# Value Engineering

PROJECT:  
BLACK ROCK DAM MODIFICATION

DATE: APRIL 22, 1993

VALUE ENGINEERING STUDY  
PROJECT:  
**BLACK ROCK DAM MODIFICATION**

**VE PROPOSAL NO. 2 - Caisson Tower**

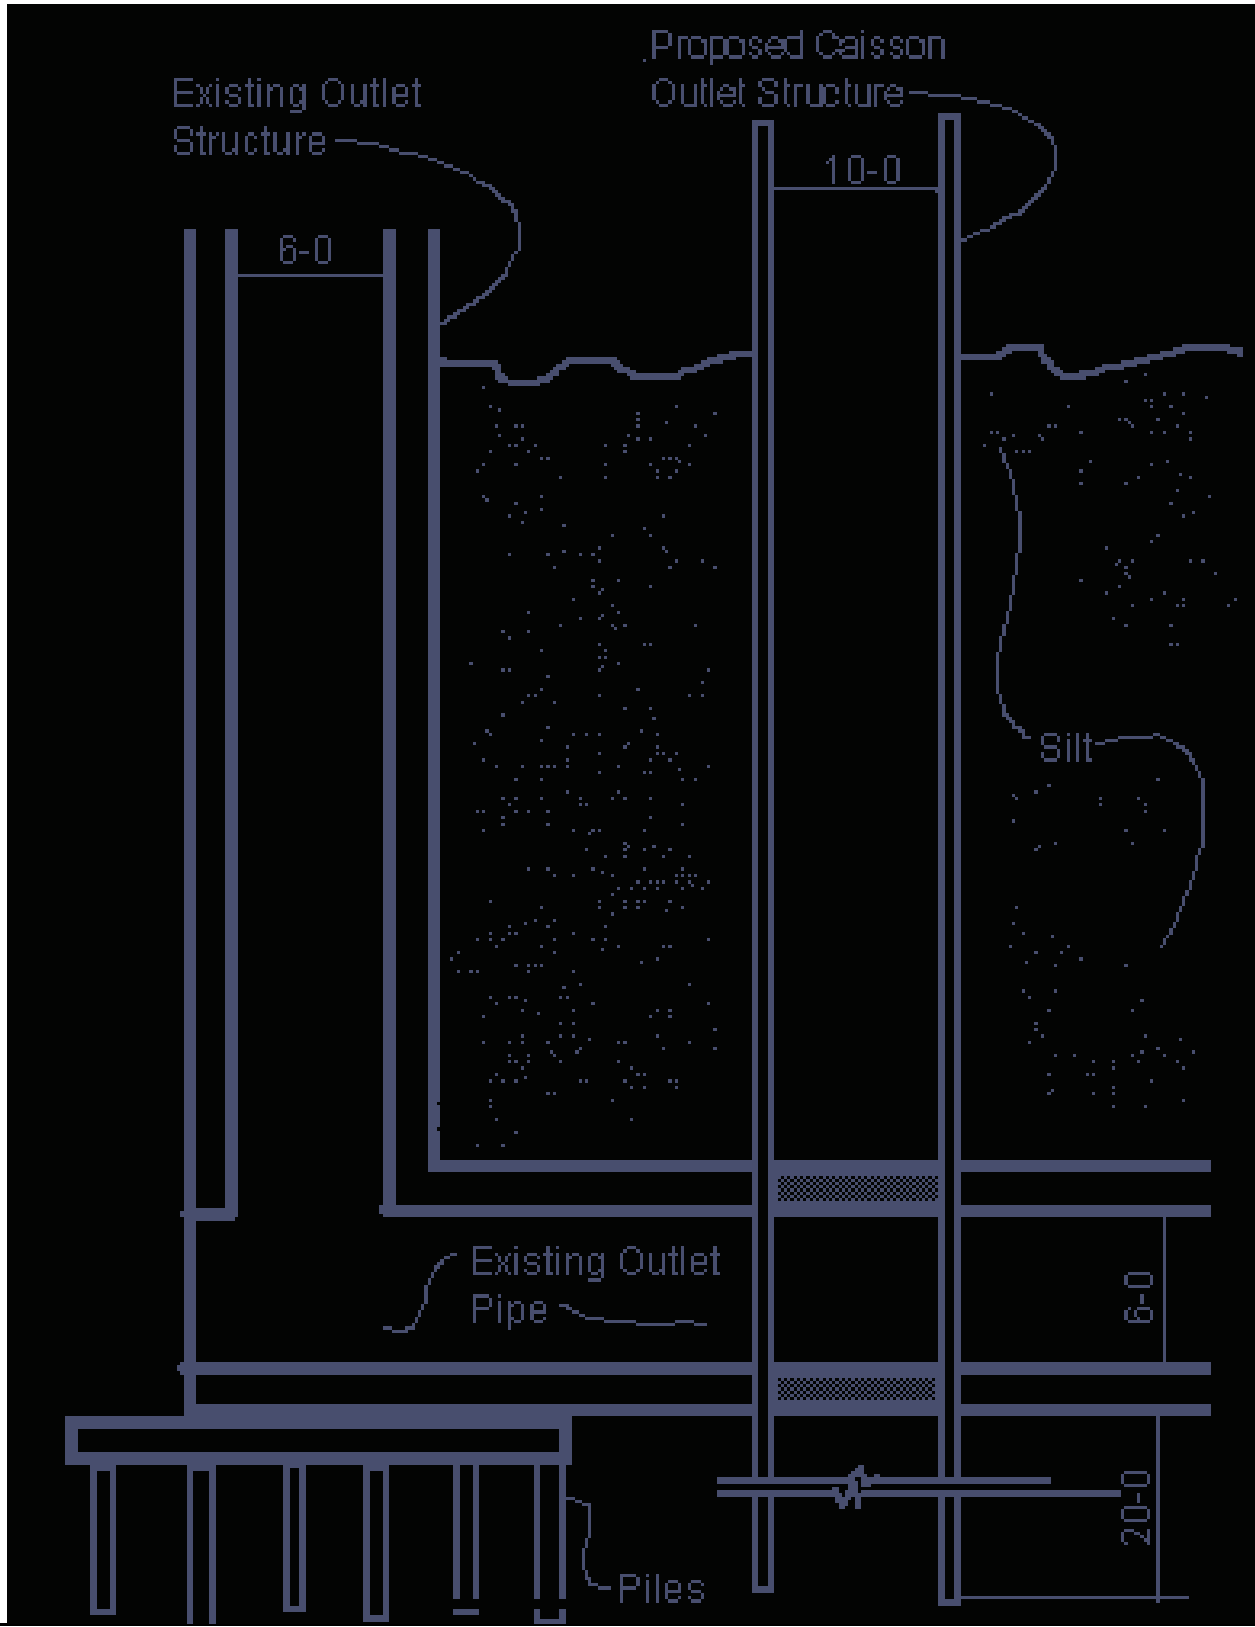
## PROPOSAL NO. 1. USE PRECAST CONCRETE CAISSON FOR THE OUTLET WORKS

Use a 10-foot diameter precast concrete caisson for the outlet works tower.

! The caisson would be dropped into the ground as the excavation is advanced by clamshell. A steel shoe would be required on the bottom edge of the caisson. From the bottom of the pipe elevation, excavation may be performed by jetting. The jets would be attached to the outside of the caisson.

! The connections between the segments of the caisson need to be waterproofed and attached firmly locking the segments together. If the segments are not firmly attached and separate due to differential settlement, the gate rod could bend.

! The caisson may be able to be used as a friction pile; if not, then it could be supported by piles driven through the caisson or by a longer caisson. This alternative includes piles and a pile cap.

! Dewatering may be required on the final design method. The dewatering may be performed at the bottom of the caisson. The jets mentioned above may be able to perform the dewatering.

<b>CRITICAL ITEMS TO CONSIDER:</b>
! The outlet tower is used to control the flow of water through the embankment.
! If improperly founded, the tower could fail during the MCE.
! The cost estimate obtained within the study appeared low to the study team. However, only one caisson is proposed and the cost estimate may be closer than it appeared during the study session. (Even if the costs were to double, this alternative is still an excellent savings.)
<b>PROBLEMS AND HOW THEY CAN BE OVERCOME:</b>
! The designers need to evaluate if piles are required for the foundations.
! The method for seating the caisson the last 20 feet needs to be evaluated by jetting or excavation.
! Dewatering (working in the dry) or placement of a cutoff floor by tremieing needs to be evaluated.
<b>PROCEDURES: (WHO DOES WHAT)</b>
! Future explorations are required to determine the foundation material for the caisson.
<b>SUMMATION OF BENEFITS AND DRAWBACKS OF THE VE PROPOSAL:</b>

PROJECT: Black Rock Dam		
COMPONENT: Outlet Works Tower	FUNCTION: Control Water	
ORIGINAL CONCEPT	VE CONCEPT	
<p>! Excavate the silt around the existing tower at a 6(H):1(V) slope to about a 40-foot depth.</p> <p>! Remove existing tower and replace with new two bay tower, using existing pile foundation. Use 36-inch gates and tie into relined pipe.</p> <p>! Backfill silt around tower.</p> <p>Notes:</p> <p>! No estimate was included for dewatering. Dewatering for this concept may be necessary.</p> <p>! The wood piles in the existing foundation may have reached the end of their useful life. If this concept is carried to further design stages, further study will be required.</p>	<p>! Insert a temporary bulkhead in existing outlet pipe to prevent inflow of silt.</p> <p>! Simultaneously place 10-foot diameter precast concrete caisson and excavate silt from inside caisson.</p> <p>! Break existing pipe with clamshell. Caisson will extend past pipe approximately 20 feet.</p> <p>! At bottom of pipe elevation, jetting may be possible to advance caisson. The other option would possibly require excavation to bottom of caisson elevation (20 feet below pipe elevation). If this material is excavated out, it will need to be backfilled after caisson installation.</p> <p>! Caisson may be adequate as self-contained foundation by using side friction or end friction; if not, piles need to be installed inside of caisson or a deeper caisson. Piles are included in this alternative.</p> <p>! After caisson and piles are installed, install pilecap and floor of tower. Two options: 1) without dewatering, tremie concrete down to form a seal and pile cap; or 2) dewater from inside or outside of caisson, and work "in the dry." Dewatering is not factored in the cost estimate.</p>

**VE PROPOSAL NO. 3 - Brace Cut Excavation for Outlet Tower**

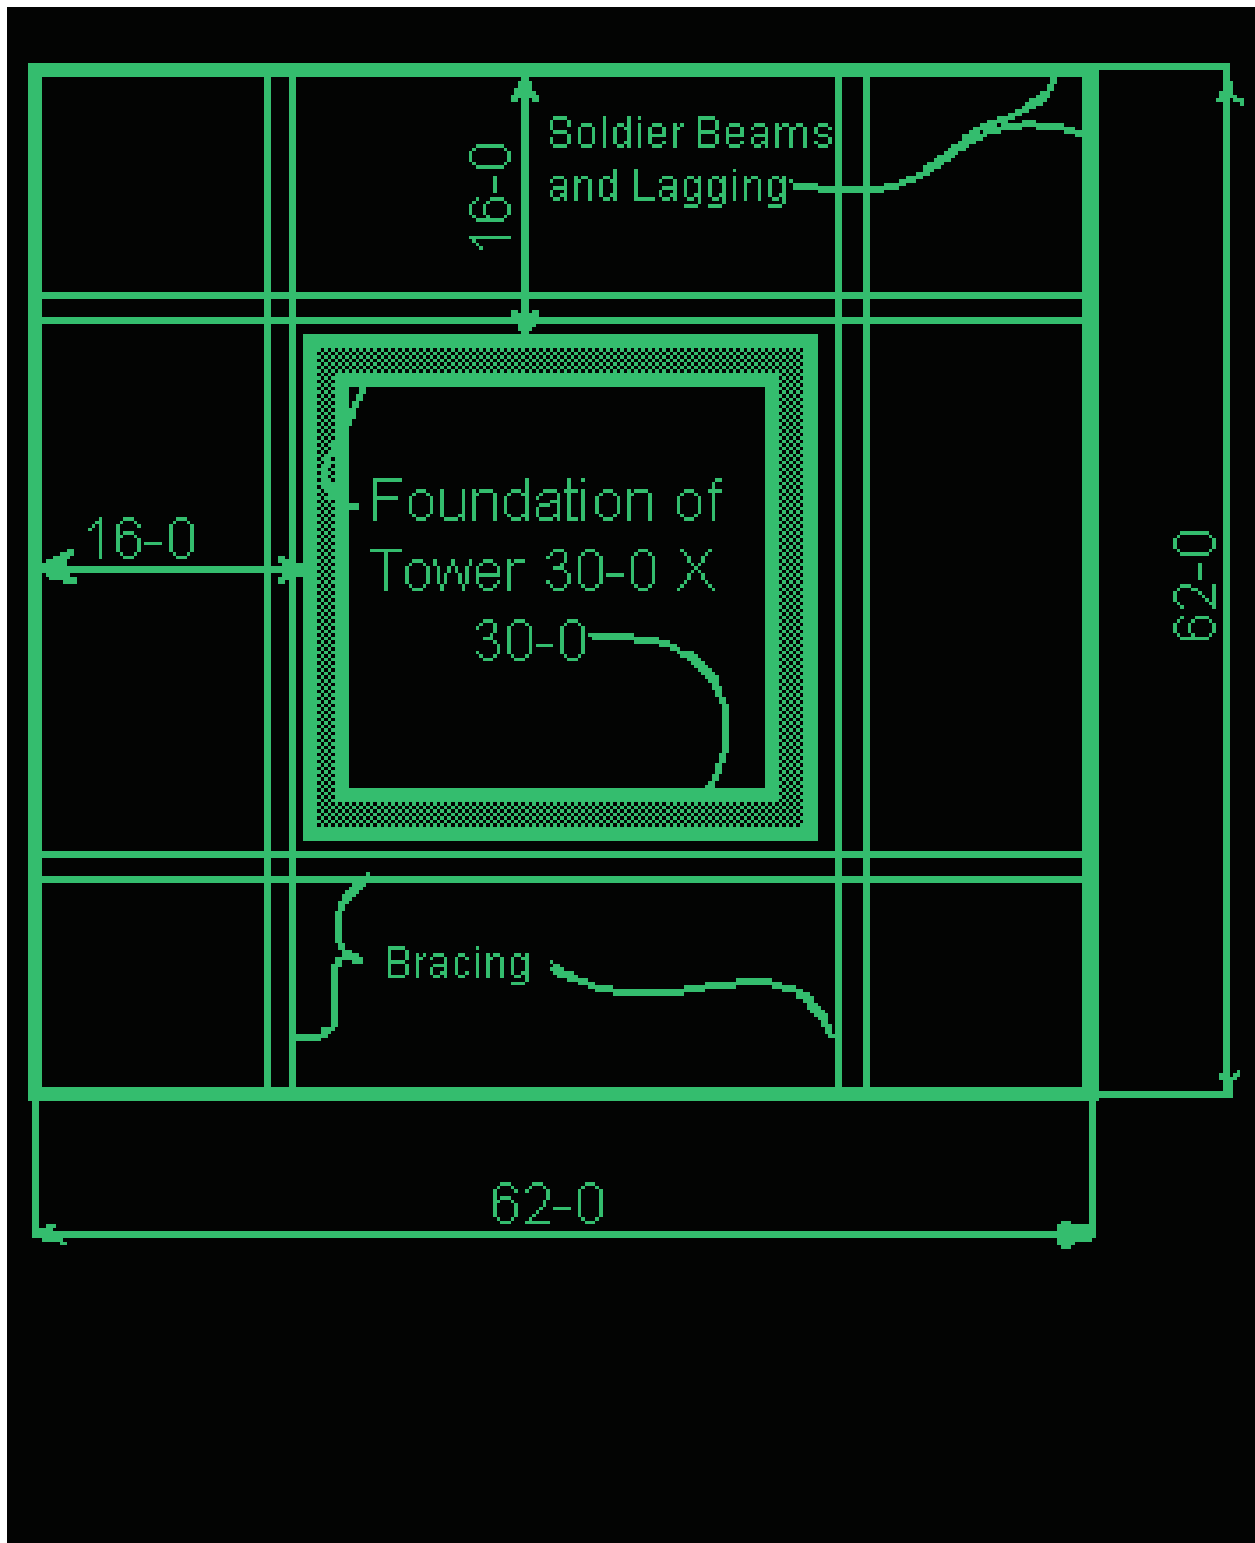
#### PROPOSAL NO 3. BRACE CUT EXCAVATION OF OUTLET TOWER

Use a braced cut excavation method in place of 6(H):1(V) sloped open excavation.

! Soldier beams and lagging may be required and may be too deep for sheet piles. This proposal used soldier beams.

! Dewatering is expected to be required.

CRITICAL ITEMS TO CONSIDER:
! The outlet tower is used to control the flow of water through the embankment.
! If improperly founded, the tower could fail during the MCE.
PROBLEMS AND HOW THEY CAN BE OVERCOME:
! The designers need to evaluate if piles are required for the foundations.
! The bracing used for the walls could interfere with the work. If driving piles are determined to be required to support the foundation, bracing may not be feasible.
! Dewatering (working in the dry) will probably be required.
PROCEDURES: (WHO DOES WHAT)
! Future explorations are required to determine the foundation material of the soldier beams and tower structure.
SUMMATION OF BENEFITS AND DRAWBACKS OF THE VE PROPOSAL:
<b>Advantages:</b> This alternative avoids the large number of unknowns related to the excavation of the silt and mobility in getting to the site with a large amount of heavy equipment.
<b>Disadvantages:</b> A specialty contractor will be required. The interference from the bracing will inhibit some operations.

PROJECT: Black Rock Dam		
COMPONENT: Outlet Works Tower	FUNCTION: Replace Tower	
ORIGINAL CONCEPT	VE CONCEPT	
<p>! Excavate the silt around the existing tower at a 6(H):1(V) slope to about a 40-foot depth.</p> <p>! Remove existing tower and replace with new two bay tower, using existing pile foundation. Use 36-inch gates and tie into relined pipe.</p> <p>! Backfill silt around tower.</p> <p>Notes:</p> <p>! No estimate was included for dewatering. Dewatering for this concept may be necessary.</p> <p>! The wood piles in the existing foundation may have reached the end of their useful life. If this concept is carried to further design stages, further study will be required.</p>	<p>! Drive soldier beams around existing tower (or new location).</p> <p>! Excavate inside of beams. Insert lagging as the work progresses down. Dewater if necessary (not estimated in this proposal).</p> <p>! Place lagging around existing conduit. Cut pipe and remove, and excavate to existing foundation.</p> <p>! Remove existing tower and construct new.</p> <p>! Backfill.</p> <p>! Remove soldier piles.</p>
